Re: Inland Empire Energy Center Project- Docket No. 01-AFC-017  
Data Responses to CEC Staff Data Requests dated January 14, 2002

**DATA RESPONSES 1 THROUGH 161  
FOR  
INLAND EMPIRE ENERGY CENTER  
SUBMITTAL 2**

**BIO ATTACHMENT 3**  
**CUMULATIVE NITROGEN DEPOSITION ISOPLETHS**

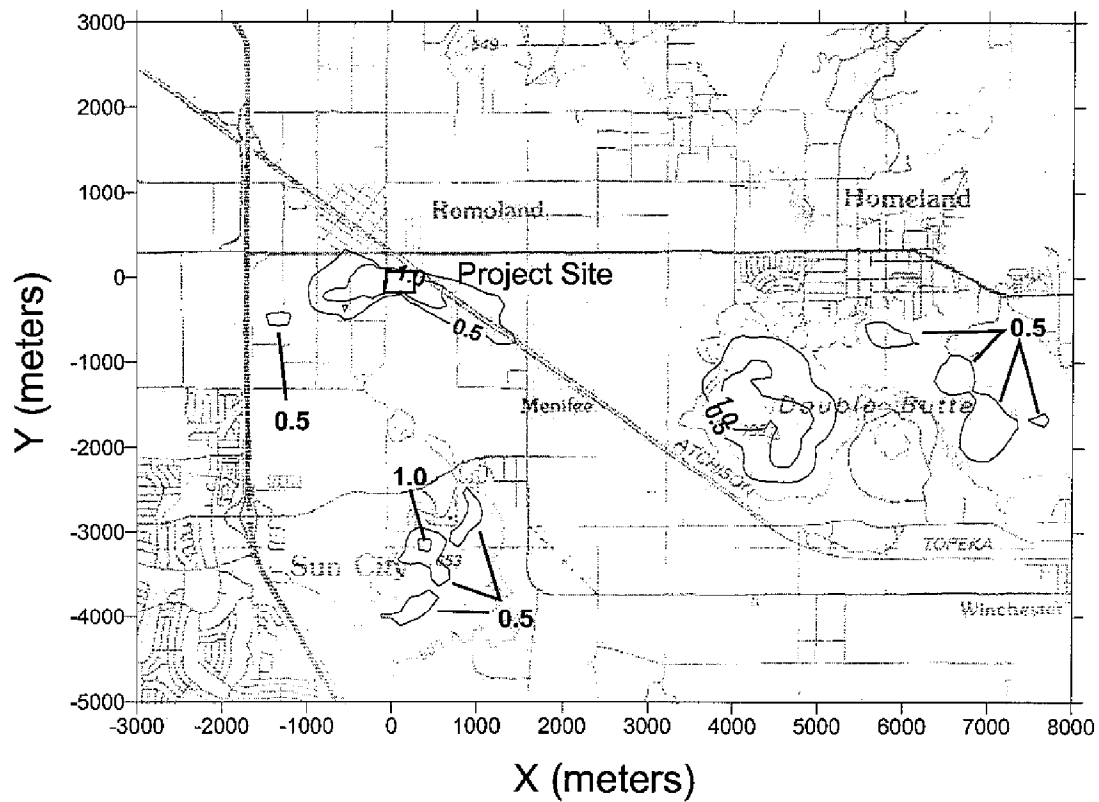
**Request 40** – Provide a matrix of projects considered in the cumulative air quality analysis proposed in Section 5.2.5 of the AFC. In your results, indicate the amount of nitrogen deposition from the cumulative projects using the values tons per year and kg/ha-yr. The matrix should include the source's distance and direction from the proposed power plant, the amount of NO<sub>x</sub> emitted using the values tons per year and kg/ha/yr, and a short description (or assumptions made) of the sources. Once all projects have been identified, using the ISCST3 model, provide the cumulative nitrogen deposition on the Class I wilderness areas identified in Table 5.3-11 of the AFC. Provide an isopleth graphic over a USGS 7.5 minute quadrangle maps (or equally detailed map or more current map) of the direct deposition values (not weighted average). Please note that Data Request #40 addresses this issue as well.

**Response 40** – See Data Response 40 in applicant's February 13, 2002 submittal. Table 40-1 summarizes the maximum modeled cumulative nitrogen deposition impacts on the nearby Class I areas. Enclosed, as Bio Attachment 3 is a figure showing the isopleths for the cumulative nitrogen deposition modeling analysis. Copies of the cumulative nitrogen deposition modeling files will be submitted to the CEC as a separate submittal.
